METROPOLITAN GOVERNMENT OF NASHVILLE AND DAVIDSON COUNTY

STAFF RECOMMENDATION 2509 ½ Natchez Trace January 21, 2015

Application: New construction-infill and outbuilding
District: Hillsboro-West End Neighborhood Conservation Zoning Overlay
Council District: 18
Map and Parcel Number: 104150048700
Applicant: Randy Robinson
Project Lead: Paul Hoffman, paul.hoffman@nashville.gov

Description of Project: The applicant proposes new construction of a single-family house with an outbuilding that does not include living space, on one of three newly subdivided lots, an area that was originally two lots.

Sheet:
A5.01

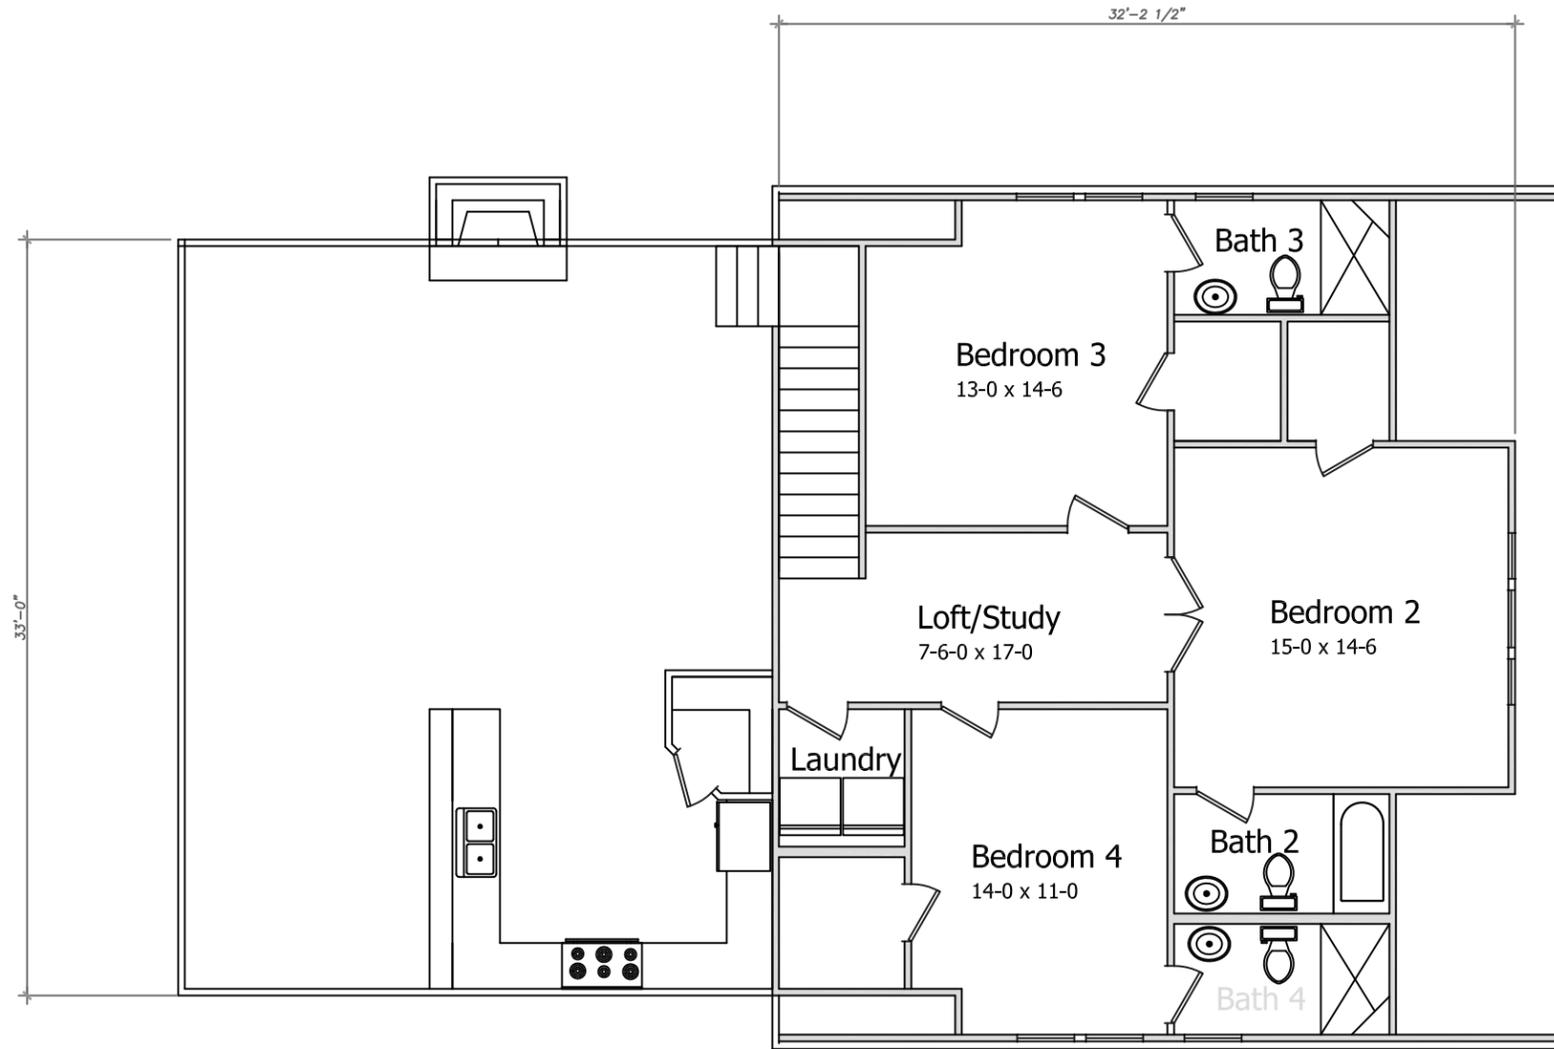
Proportion and Rhythm of Openings: The windows are generally twice as tall as they are wide, and meet the historic proportions of openings. There is an expanse of ten feet (10') on the building's left side without a window or door opening. As this is at the front of the house, Staff recommends a window opening be added to this section. With the addition of an opening in this location, Staff finds the project's proportion and rhythm of openings will meet Section II.B.1.g.

4. A window opening be added to the left side of the building, to break up the expanse there without a window opening;
5. The finished floor height shall be consistent with the finished floor heights of the adjacent historic houses, to be verified by MHZC staff in the field;

Sheet:
S1.01

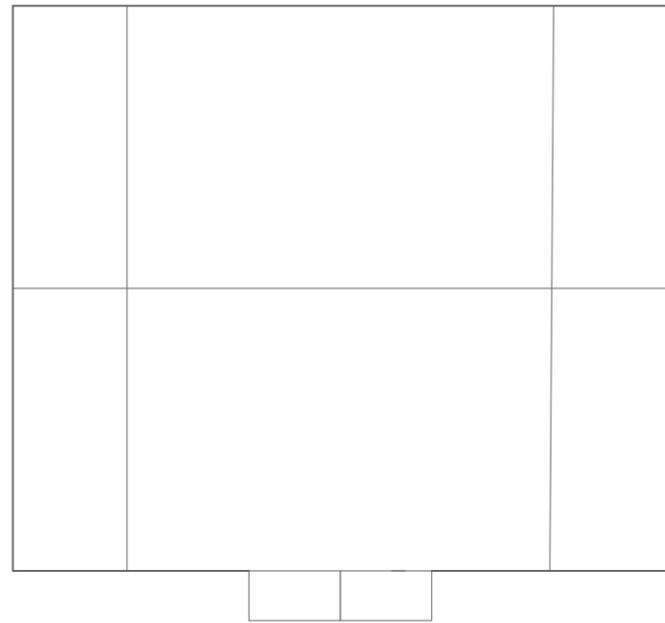
Utilities: The site plan or floor plans for this infill do not indicate the location of the HVAC units; Staff requests HVAC and other utilities be located on a rear façade, or on a side façade beyond the midpoint of the house.

7. Staff approve the color of roofing material for the residence and outbuilding; and
8. HVAC and other utilities be located at the rear façade, or on a side façade beyond the midpoint of the house.

Sheet:
A7.01

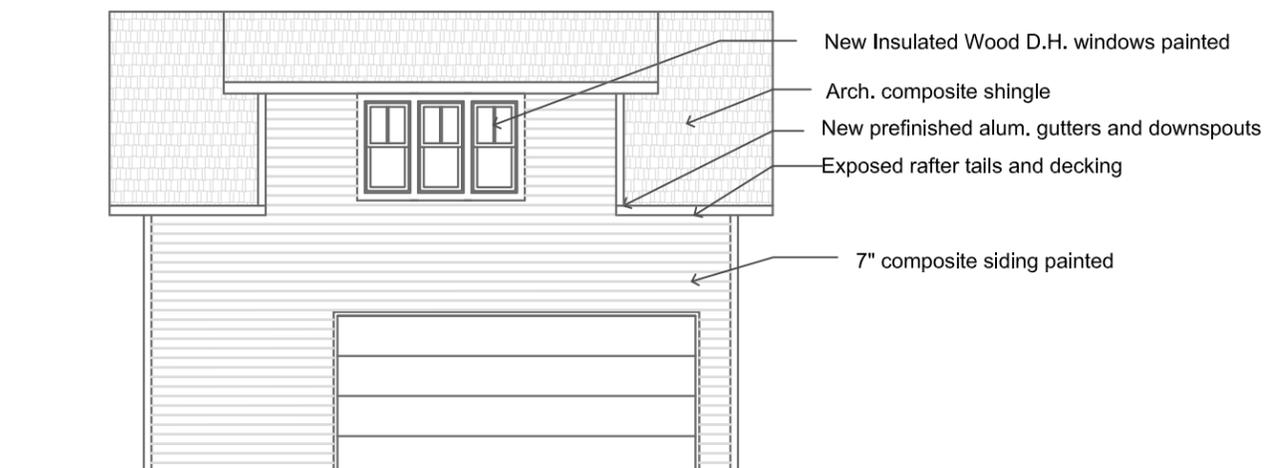
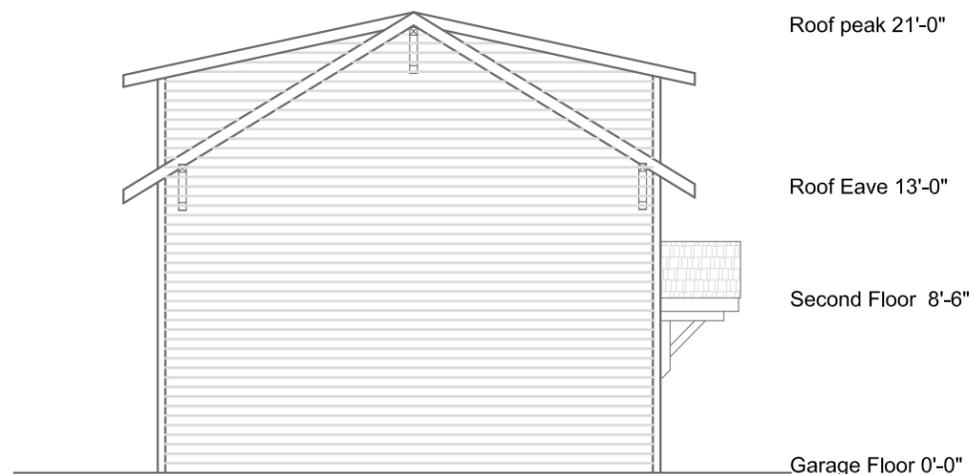
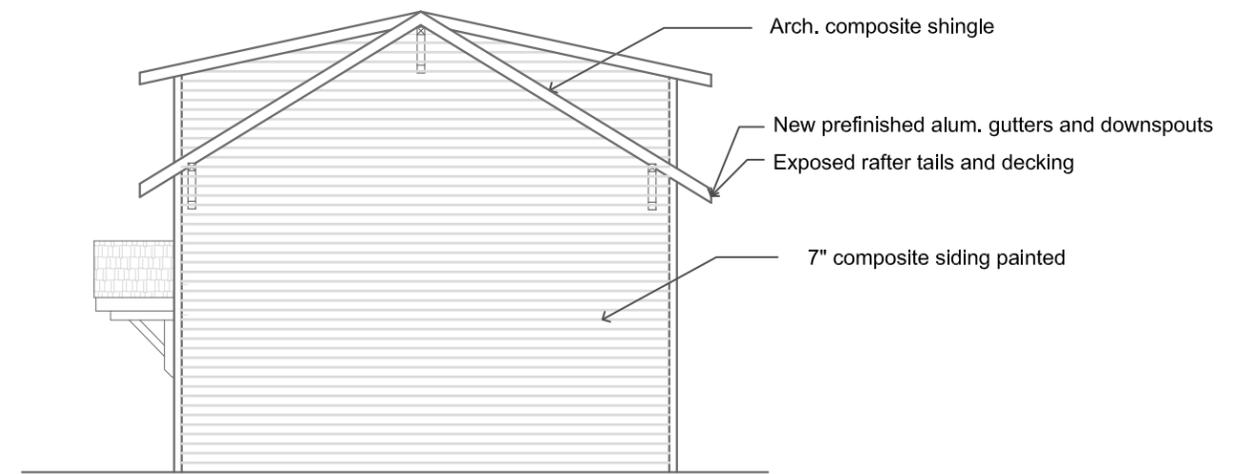
Height & Scale: The eave height of the outbuilding is eleven feet (11'); Staff requests this be lowered to ten feet (10') to meet section II.B.h of the design guidelines.

Character, Details, Roof: The proposed design of the outbuilding is compatible with the house. The roof is a side-gabled form with approximately 8/12 pitch. The dormers as drawn cover exactly 50% of the roof plane, but as they are wall dormers, they do not sit back from the wall. Staff requests the dormers be redesigned as roof dormers that sit back from the exterior wall by no less than two feet (2').

Materials, Siding & Trim: The materials will be the same as for the proposed residence. It will be built on a concrete slab. The siding material was not specified; Staff requests approval of the material. The reveal also was not specified, and Staff asks that the reveal be no greater than five inches (5"). Roofing will be architectural shingles in a color to be approved by Staff.

1. Lap siding have a reveal no greater than five inches (5");
2. The outbuilding's eave height be lowered to no more than ten feet (10');
3. The outbuilding's dormers be redesigned to be roof dormers, sitting back from the wall beneath by no less than two feet (2');
